TEXAS UTILITIES ELECTRIC COMPANY  
COMANCHE PEAK STEAM ELECTRIC STATION, UNIT 1  
DOCKET NO. 50-445  
AMENDMENT TO FACILITY OPERATING LICENSE

Amendment No. 46  
License No. NPF-87

TEXAS UTILITIES ELECTRIC COMPANY  
COMANCHE PEAK STEAM ELECTRIC STATION, UNIT 2  
DOCKET NO. 50-446  
AMENDMENT TO FACILITY OPERATING LICENSE

ATTACHMENT TO LICENSE AMENDMENT NOS. 46 AND 32

FIGURE 5.6-1

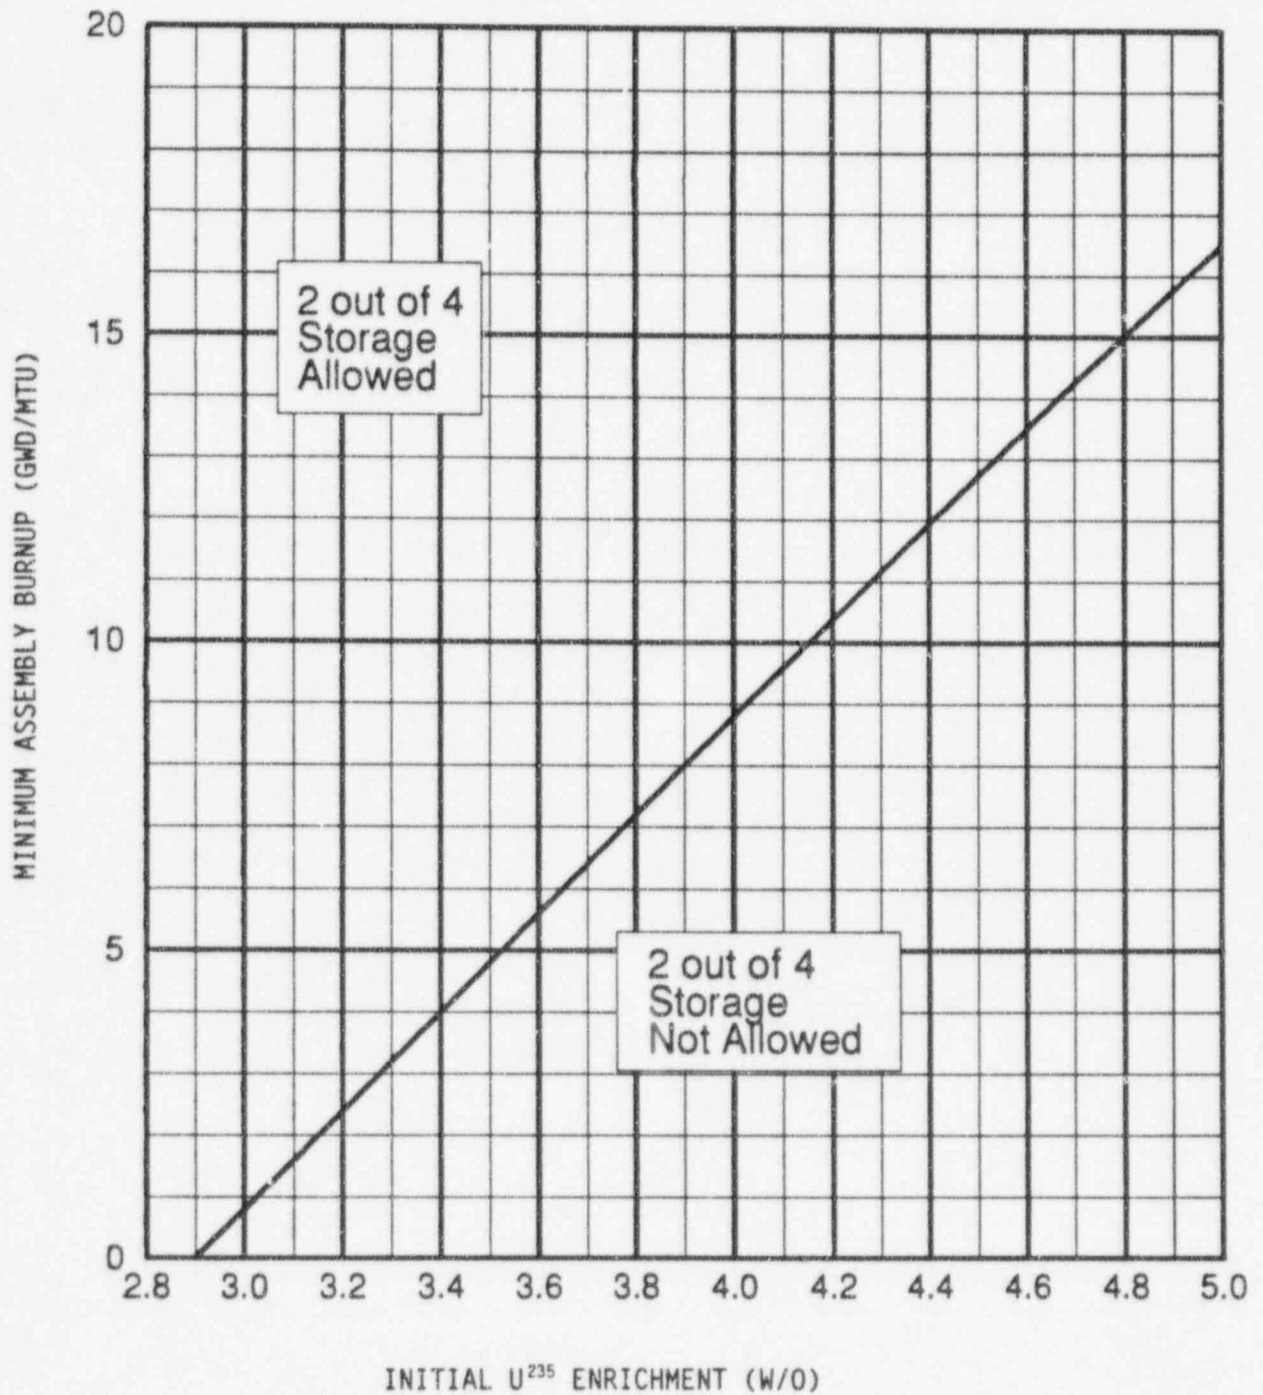
- f. New or partially spent fuel assemblies which meet the minimum burnup-initial enrichment requirements of Figure 5.6-1 are allowed restricted storage in a checkerboard (2 out of 4) pattern in the high density fuel storage racks.
